Comments on Aviation Assessment submitted with Planning Application 19/02708/OUT

Introduction

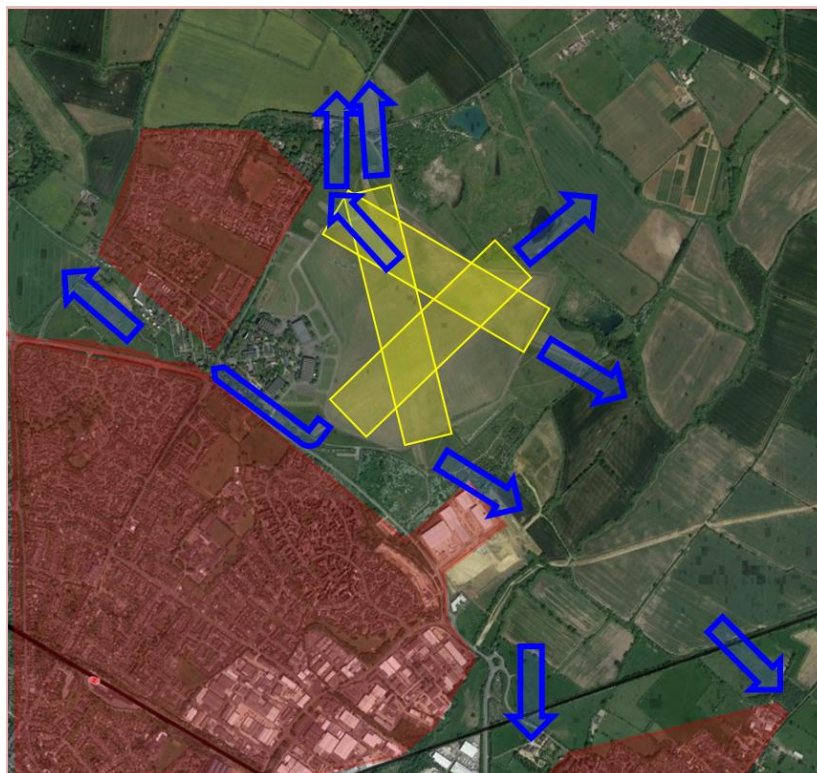
Comment 3.

The aviation assessment states in paragraph 4 that;

“The orientation chosen [for take-off and landing] will depend on the wind conditions. At Bicester, as at most UK airfields, the prevailing wind direction is from the southwest.” The assessment then presumes, *“Given these conditions, it is clear that the majority (probably around 80 percent) of take-offs and landings, including glider launches by winch, will be in the R06/24 direction into wind”*.

In fact, wind direction is only one factor. Risk management of launching at Bicester, which is partly surrounded by development, results in careful selection of take-off directions and climb out routes to avoid in so far as possible the overflight of buildings. See diagram below. An analysis of the 871 flight logs available for 2018 and 2019 shows just 17% of aero-tows from run 24, with that run used on 18% of days that aero-tow records are available. The new technical site development by Bicester Motion will make the run 24 departure route even less attractive, so this proportion is likely to reduce in future.
